PROPOSED ALTERATIONS AND  
EXTENSIONS  
THE OLD FORGE  
STAINSAKRE  
FOR MR JOHN STAINTHORP  
PROPOSED ELEVATIONS

REVISED DRAWING

PROPOSED ALTERATIONS AND  
EXTENSIONS  
THE OLD FORGE  
STAINSACRE  
FOR MR JOHN STAINTHORP  
SCALE 1:100  
PROPOSED FLOOR PLANS TD/ 113

**From:** john stainthorp  
**Sent:** 13 December 2013 13:49  
**To:** Helen Webster; Planning;  
**Subject:** RE: [NYM/2013/0386/FL](#) - The Old Forge

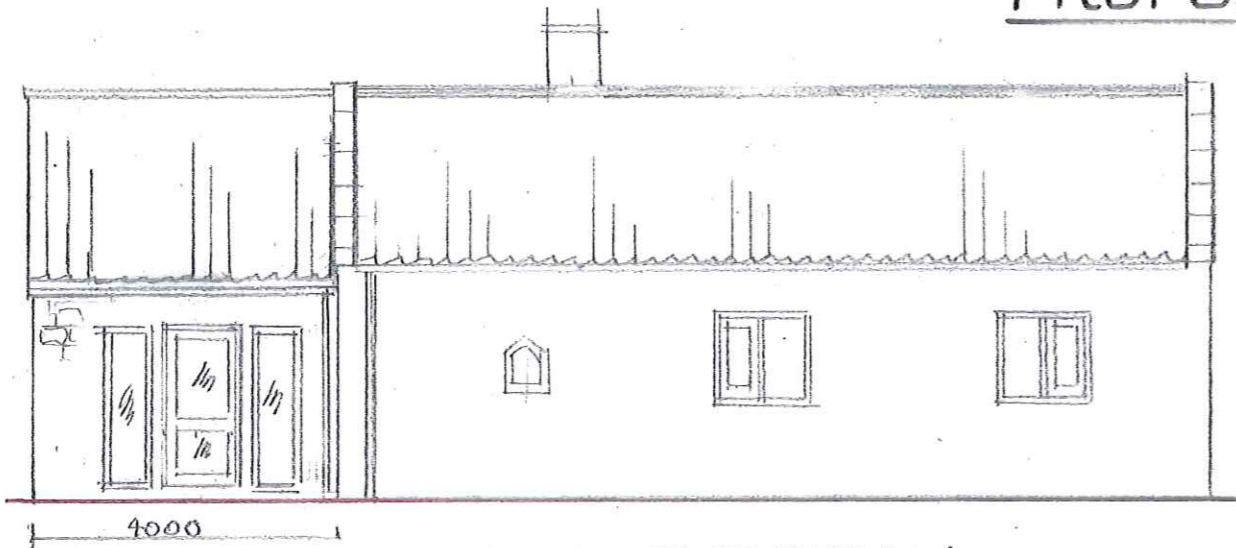
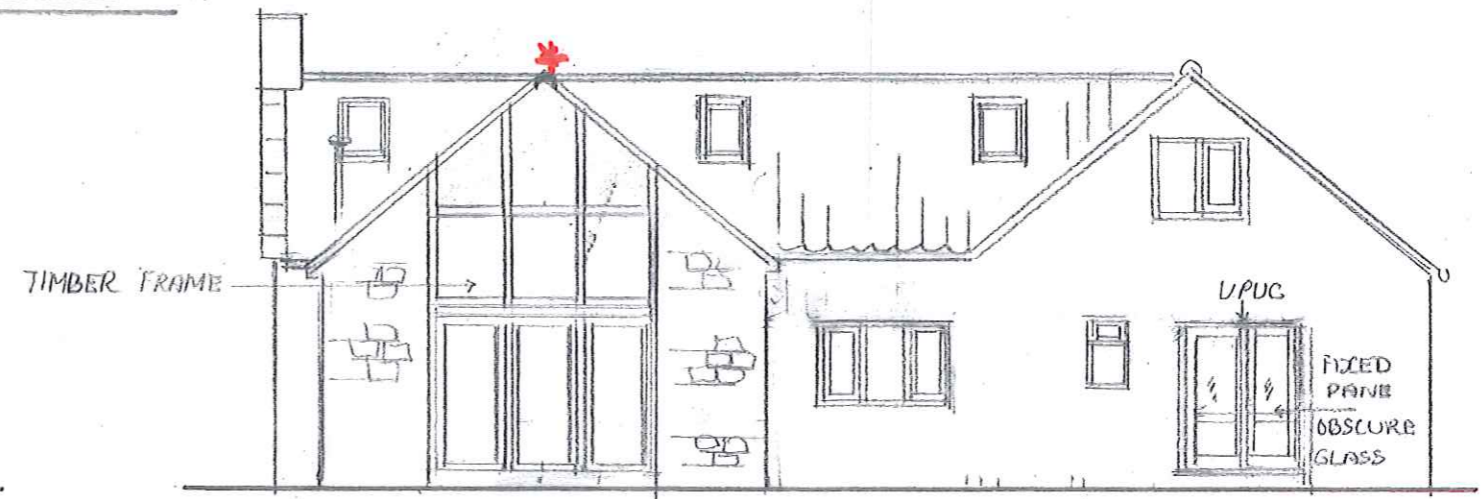
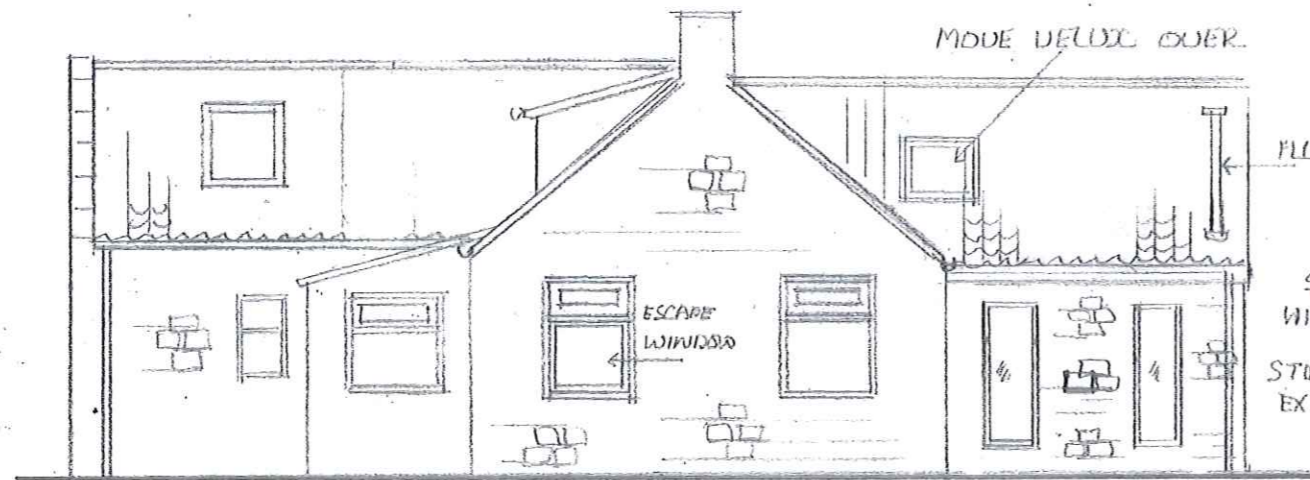
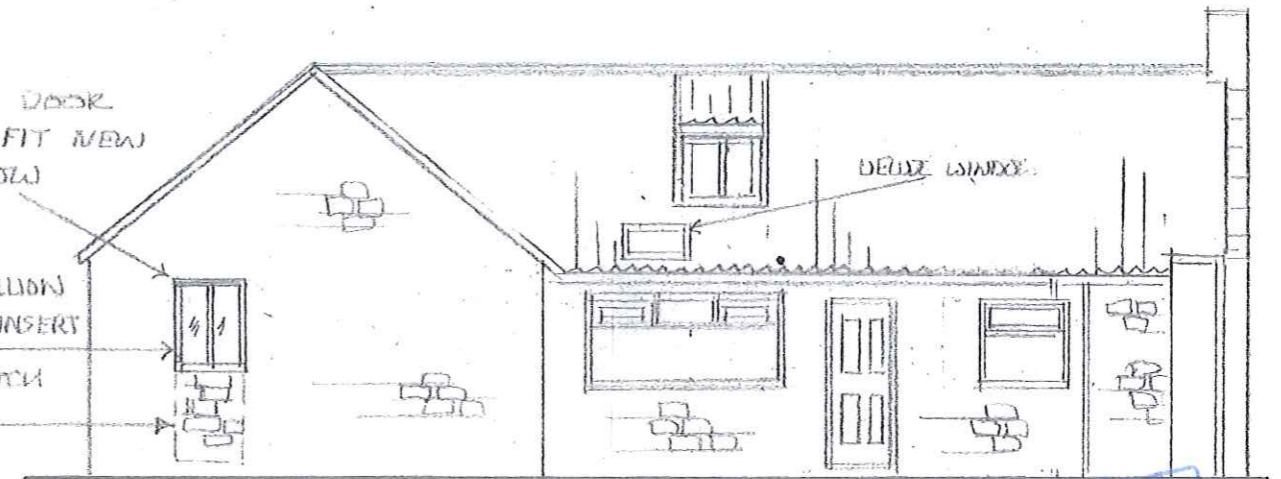
Increase in height of sunroom roof to match host property

Altered design of window opening(s) to replace 'front door' to annexe

Revised window details to include design, material (timber), paint finish, reveals

REMOVE DOOR  
AND FIT NEW  
WINDOW

STONE MULLION  
WITH TIMBER INSERT

STONE TO MATCH  
EXISTING

DOORS AND WINDOWS PAINTED CREAM  
ALL TIMBER DOUBLE GLAZED  
WITH SAFETY GLASS IN CRITICAL LOCATIONS  
8000mm TRICKLE VENTS

*The Door opening will not now be made any wider and will be stoned up at the bottom with the same stone that the house is built of, the opening will be split with a sandstone mullion and lined around the edge with a similar sandstone lining. There will then be a slim timber frame just enough to take the glass panes that will be fitted and the whole thing will be recessed 300 mm or as much as possible as the wall is modern cavity and not the original building.*

*We will remove all UPVC windows and fit modern timber windows in the general lip casement style. The painted finish will be "Not White" although we would still ask for as light as possible considering that the buildings around us are white and that The Old Forge is not as thought the original building, but a demolish and modern re-build. We would be more than happy with a country cream against the random sandstone finish if that is agreeable? if not I am sure we will be able to find a compromise.*

*We would though ask that the two windows facing west over open country and up the Esk-vally be changed for timber, painted not white, but left in the same style as existing, which matches the already existing north facing porch windows, this would give us a top transom casement window with a single bottom pane and good views? (As we have now)*

*The windows will be revealed as much as possible in a modern cavity wall.*

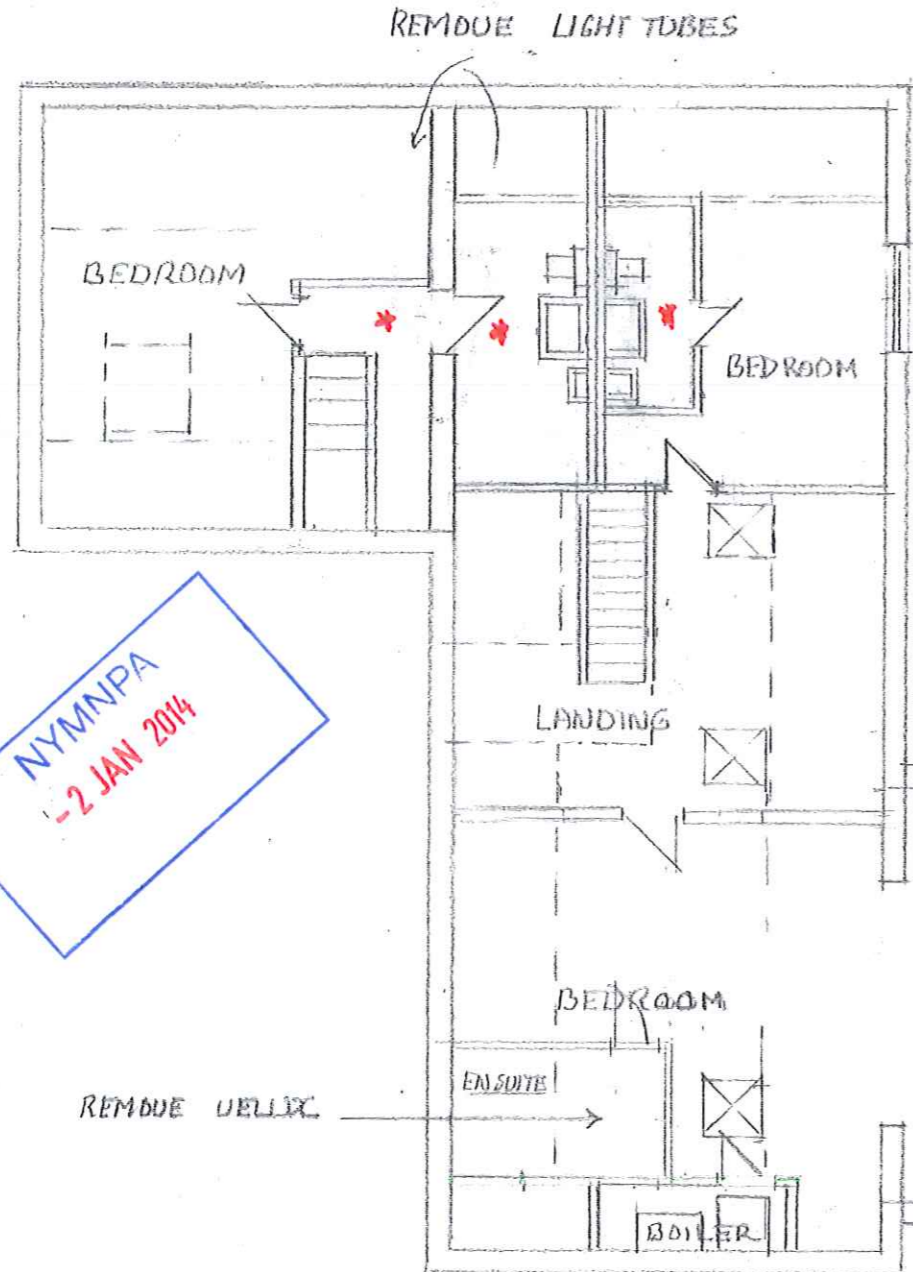
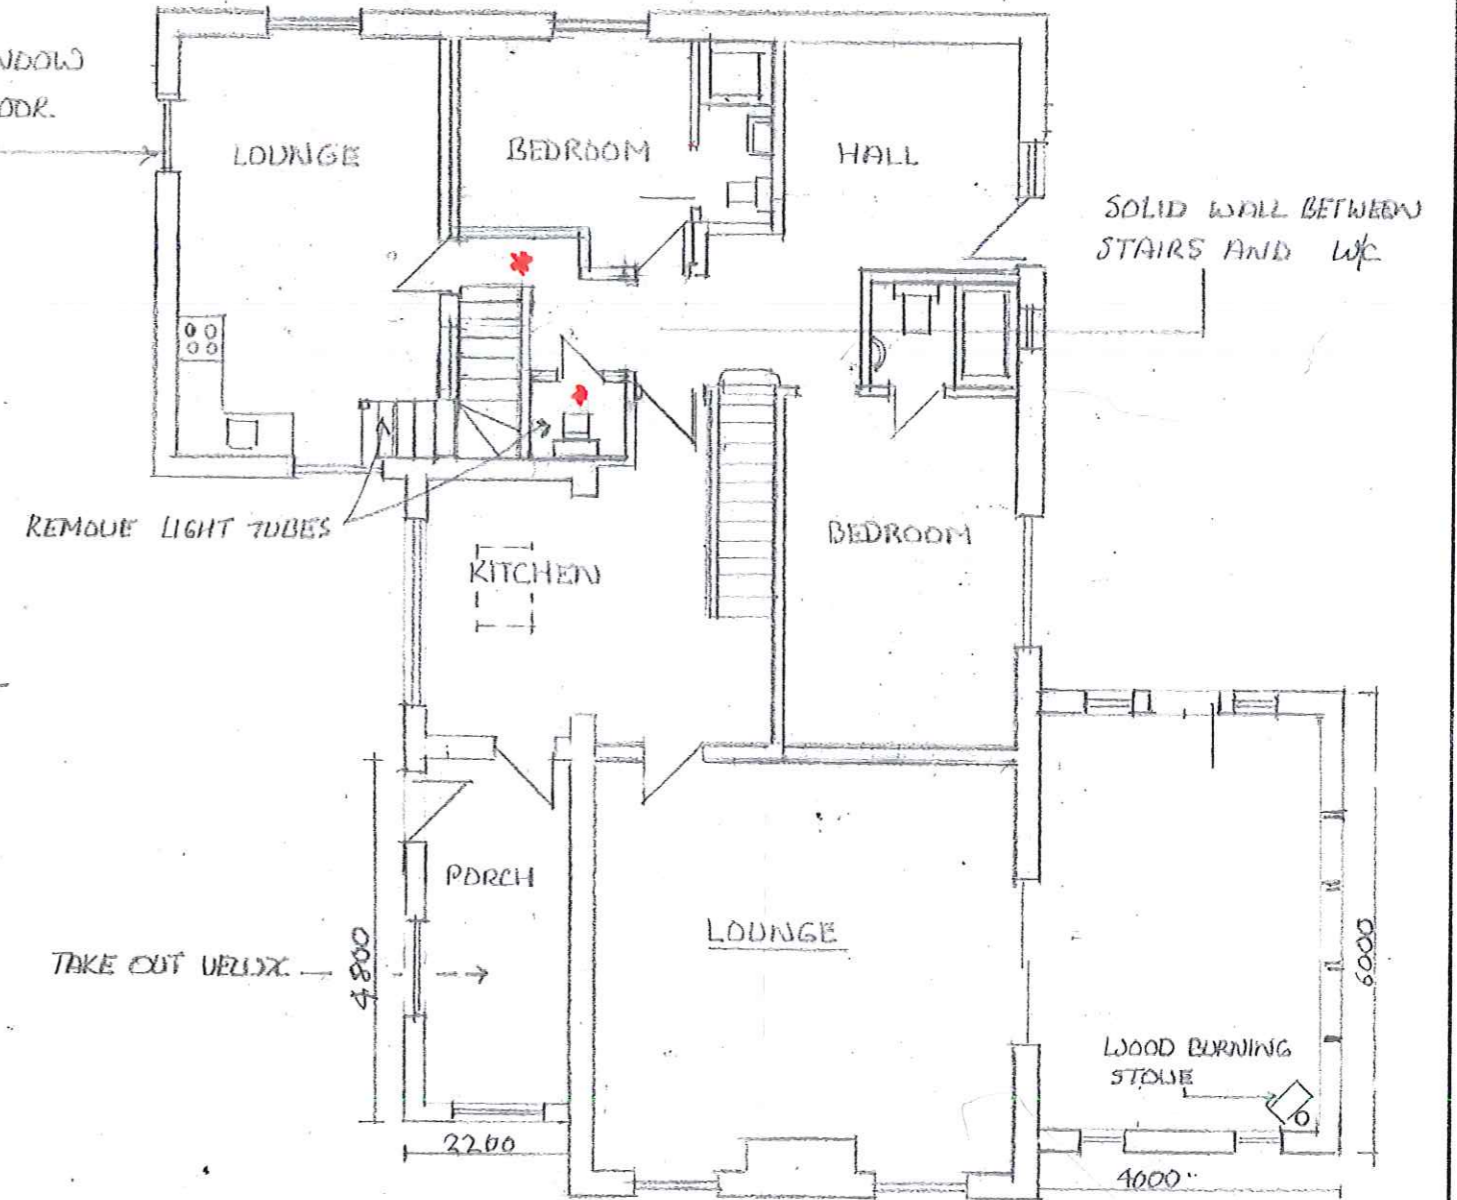
Revised, accurate floor plans having particular reference to the internal link to the 'annexe' to avoid the ground floor WC

- 1 REVISED ANNEX LAYOUT
- 2 REVISED RIDGE LINE OF EXTENSION
- 3 REVISED WINDOW IN NORTH ELEVATION

*We have discussed this and have satisfactorily agreed to re-draw the plan showing the area with the toilet door on the left as approaching the annex door that will be positioned clear of the staircase walls.*

*Also that there is room to include a en-suite on the right of the top of the stairs going up into the annex bedroom, the en-suite shower will be central to the roof apex and back to back with a shower in the adjoining bedroom on the south end of the house.*
